QUALITY ASSURANCE -- NON-CONFORMANCE REPORT

Location: Changxing Island, Shanghai, PRC **Report No:** NCR-000175
Prime Contractor: American Bridge/Fluor Enterprises, a JV **Date:** 18-Aug-2008
Submitting Contractor: Zhenhua Port Machinery Company, Ltd (ZPMC), Changxing Island **NCR #:** ZPMC-0158

Job Name: SAS Superstructure
Document No: 05.03.06-000147

Reference Description: Unqualified Welder / Double Diaphragm

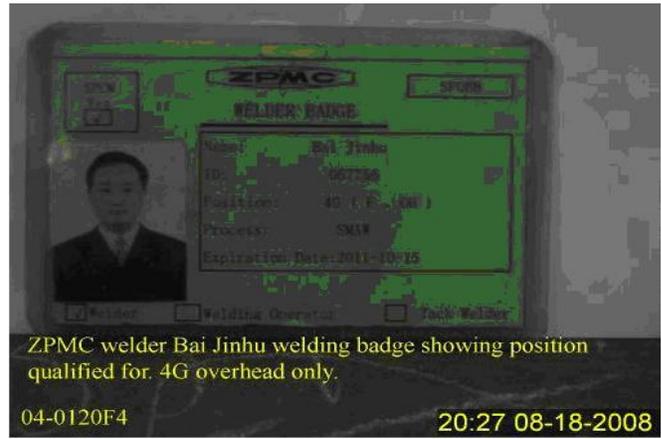
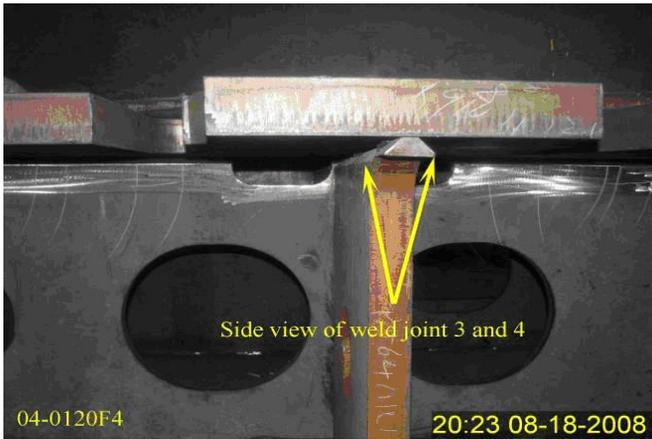
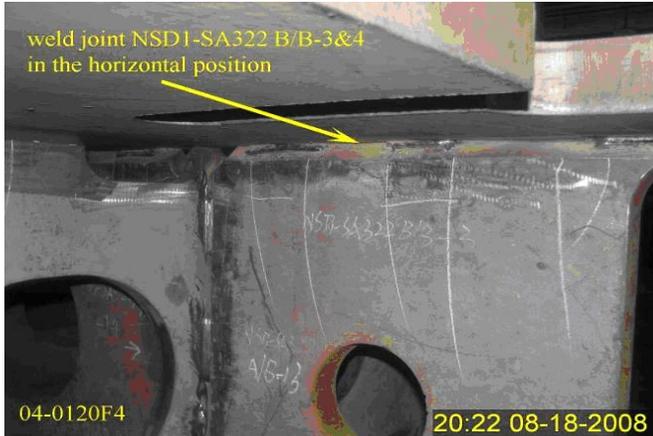
ABF allowed ZPMC to weld on the Tower component number NSD1-SA322-B/B-3 & 4 (Double Diaphragm) in the horizontal position with a welder that was not qualified to weld in this position. After the ZPMC Quality Control Inspector was informed of this discrepancy, the welder (Bai Jinhu) was allowed by Mr. Xu Jun to perform welding again in the same position and weld joint. Only after readdressing the issue with the QC Inspector did he stop the welding.

AWS D1.5-2002, Section 5.22.1, Table 5.6

The Contractor's response is acceptable. After further discussion, the weld in question is in the 4G position, and the welder was qualified in that position. The Department concurs that Non-Conformance ZPMC-0158 is closed.

WT65 & WT46

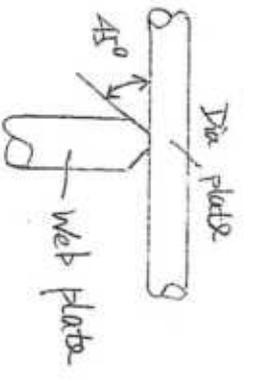
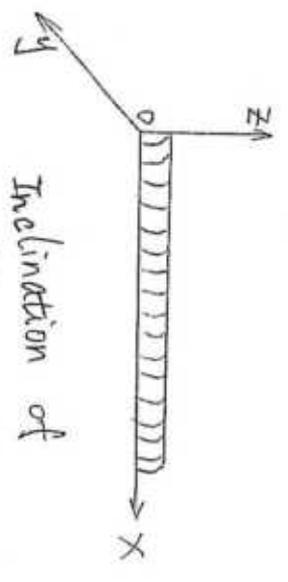
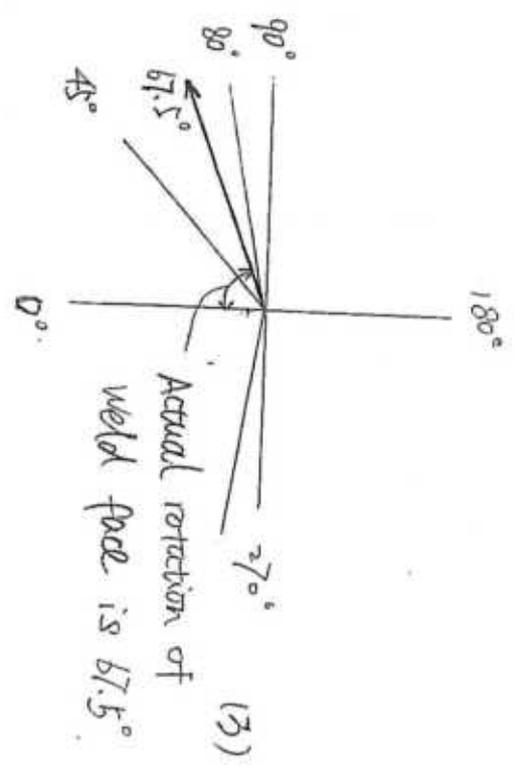
ZPMC took exception to this NCR. ZPMC arranged the 4G (4F) welder to perform the tack welding in the overhead position, which CT inspector Kenneth Riley regarded as the horizontal position. But ZPMC looked into the AWS chapter 5 figure 5.5, and joint WT 65 & WT 66. ZPMC is pretty sure the position the welder performed in is the overhead position. So ZPMC did not commit any mistake as to this NCR. Please see the attached sketch and WPS for your reference.

Inclination of weld axis is 0° .

— overhead range

The Contractor's response is acceptable. After further discussion, the weld in question is in the 4G position, and the welder was qualified in that position. The Department concurs that Non-Conformance ZPMC-0158 is closed.

Upon presentation of ABF/ZPMC's explanation that the welding was being performed in the overhead position the Department concurs that welding was being performed in the overhead (4G) position. Therefore the NCR will be closed with no further action required.
